774
Chick-fil-A

1805 VALLEY VIEW BOULEVARD
ROANOKE, VIRGINIA

UTILITY PLAN

PS1

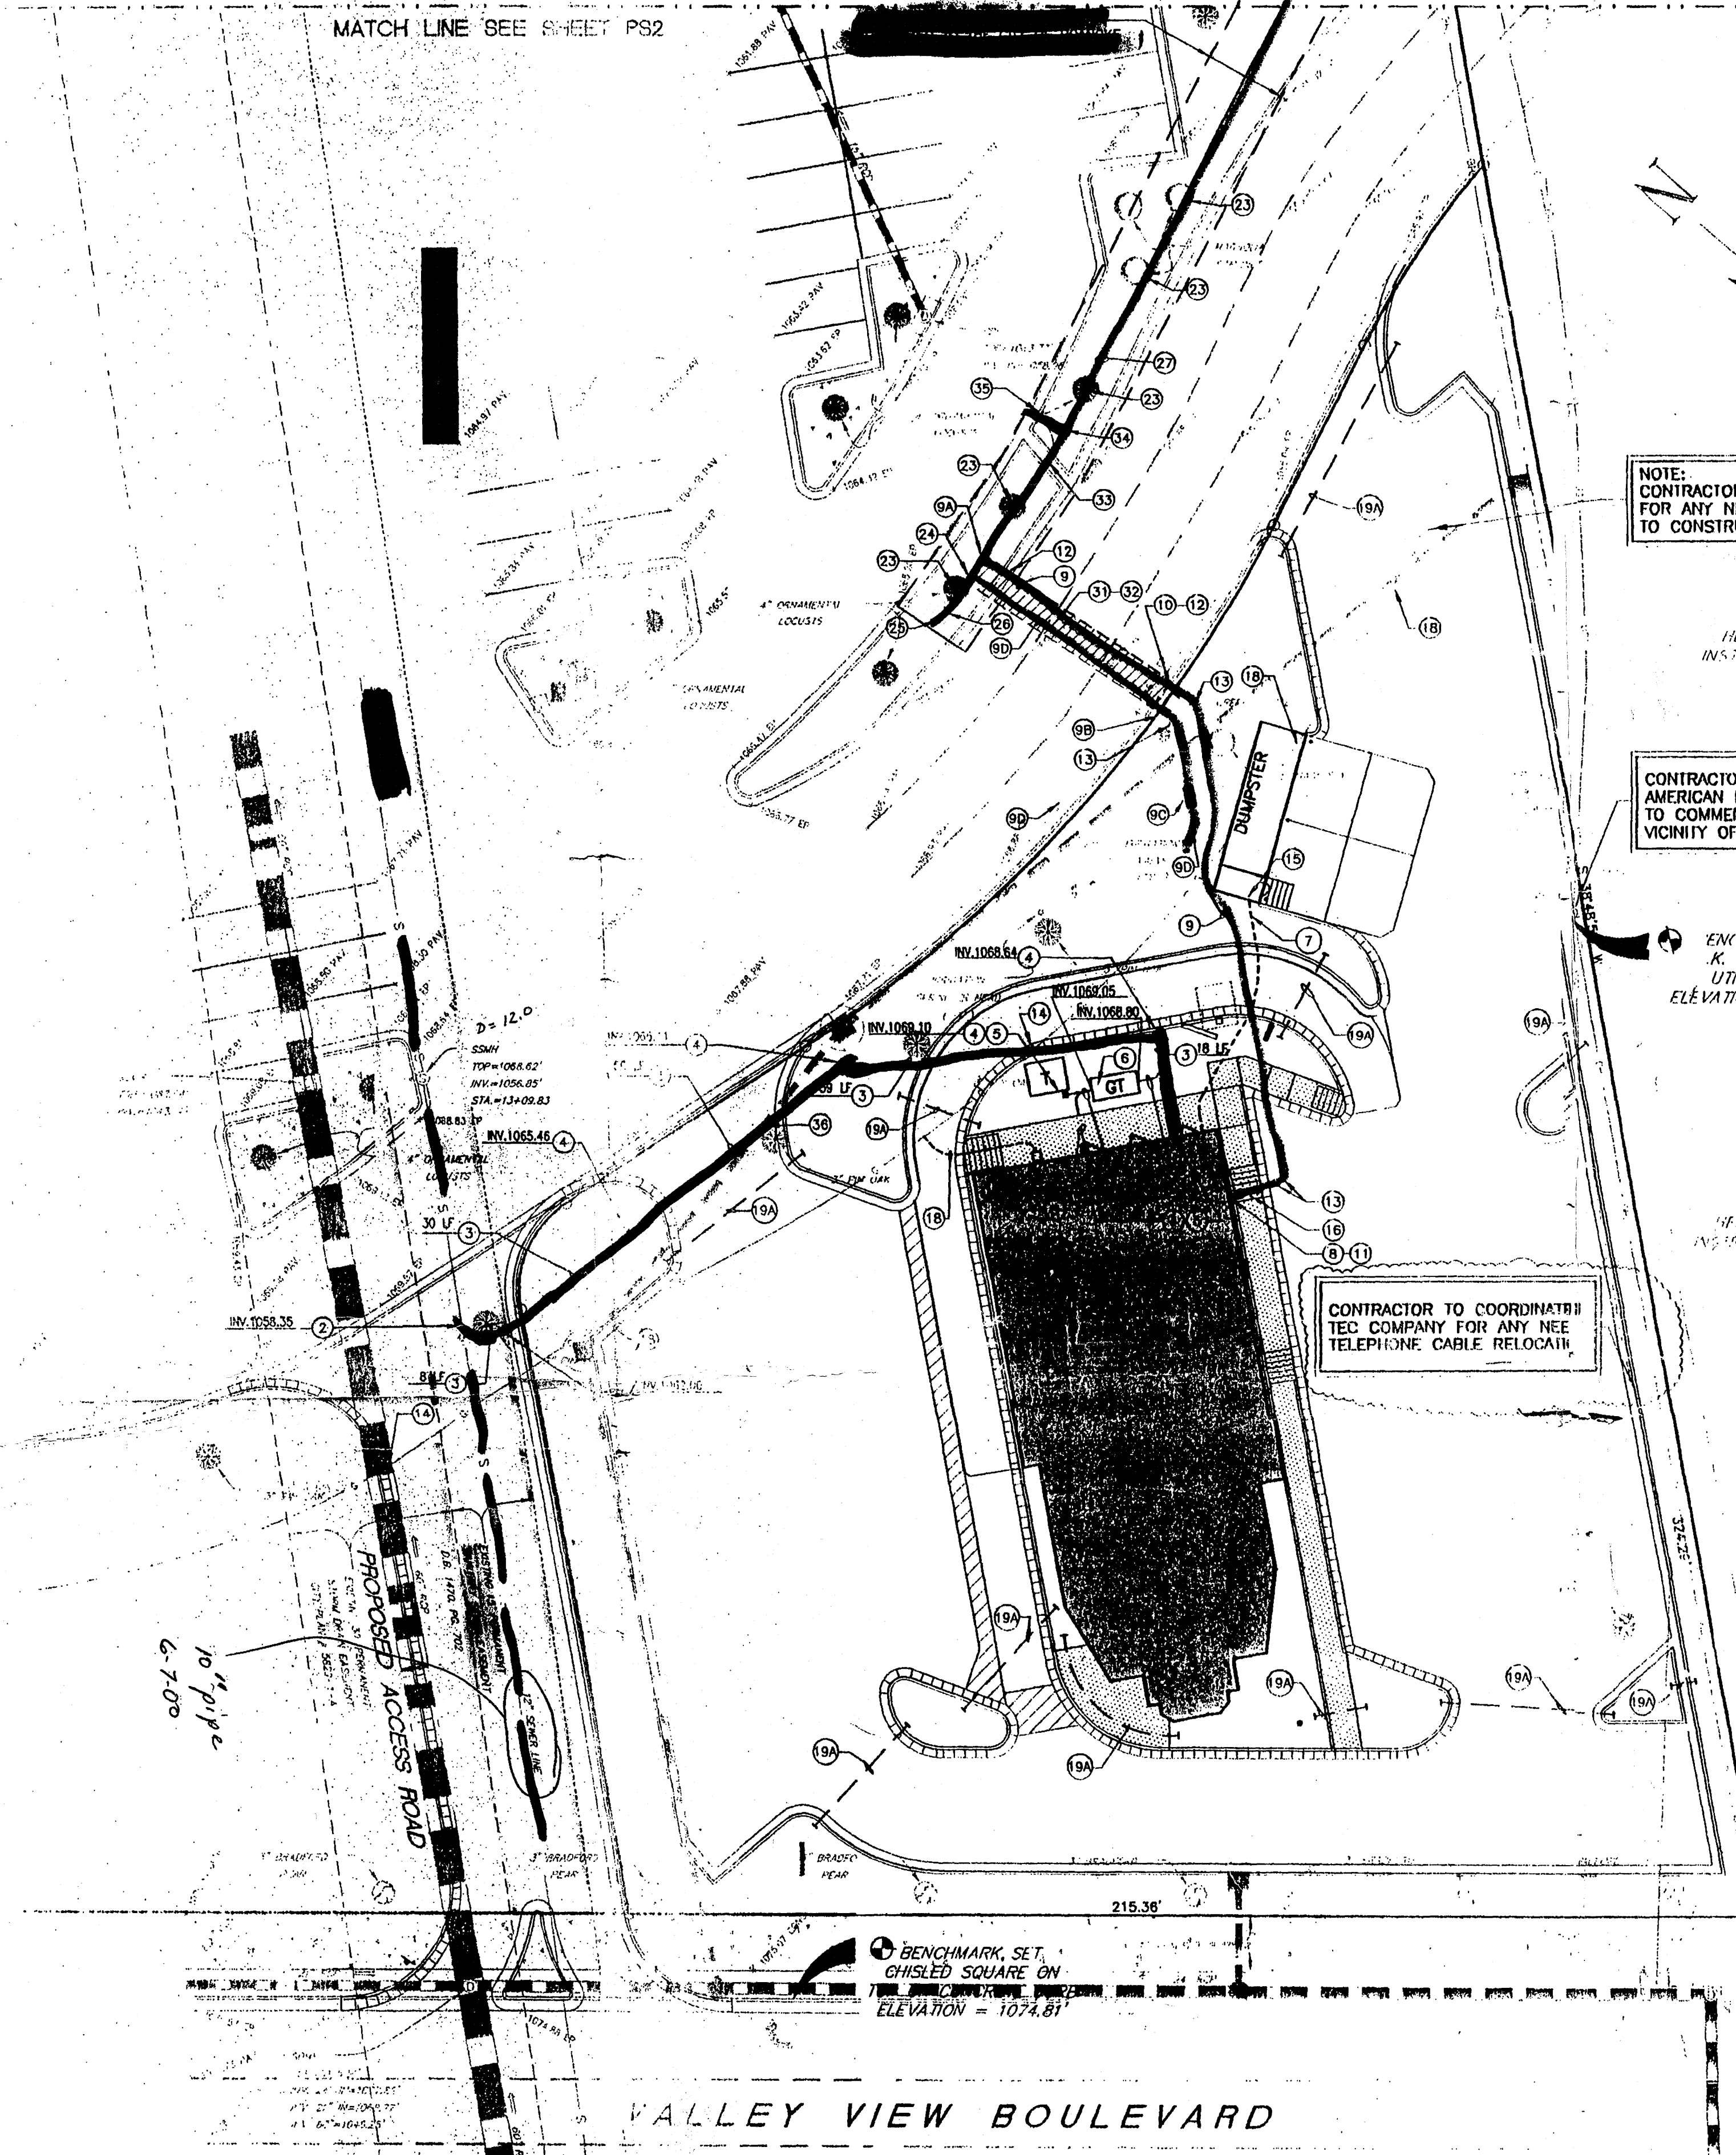
- 1/2" DOMESTIC WATER METER WITH METER BOX. *Meters to be in dedicated easement by Ed Trent 3-31-00*
- SEE ARCHITECTURAL PLANS FOR EXACT LOCATION OF WATER CONNECTION.

- NOTE
- 6" BLIND FLANGE W/ TAPPED JOINT. *Install 9' low OFF (3-31-00 Ed Trent)*
 - 6" GATE VALVE
 - 6" DUCTILE IRON WATERLINE, 36" MIN. COVER.
 - 6" - 45' BEND W/ MEGALUG RESTRAINTS
 - 6" - 22 1/2" BEND WITH MEGALUG RESTRAINTS
 - 12" X 6" TAPPING SLEEVE AND VALVE
 - 6" H CUT PAVEMENT FOR WATERLINE INSTALLATION. SEE DETAILS FOR TRAFFIC CONTROL.
 - SEE DETAILS FOR PAVEMENT PATCH, RESURFCE PAVEMENT AS REQUIRED.
 - CONTRACTOR TO REPLACE CONCRETE SWALE REMOVED FOR WATERLINE INSTALLATION WITH MATERIALS TO MATCH EXISTING.
 - 6" X 6" TEE WITH TWO TYPES OF RESTRAINTS.
 - FIRE HYDRANT ASSEMBLY W/ 6" GATE VALVE. SEE DETAIL.
 - SANITARY OVER STORM, 6" CLEARANCE. INSTALL NEOPRENE PAD.
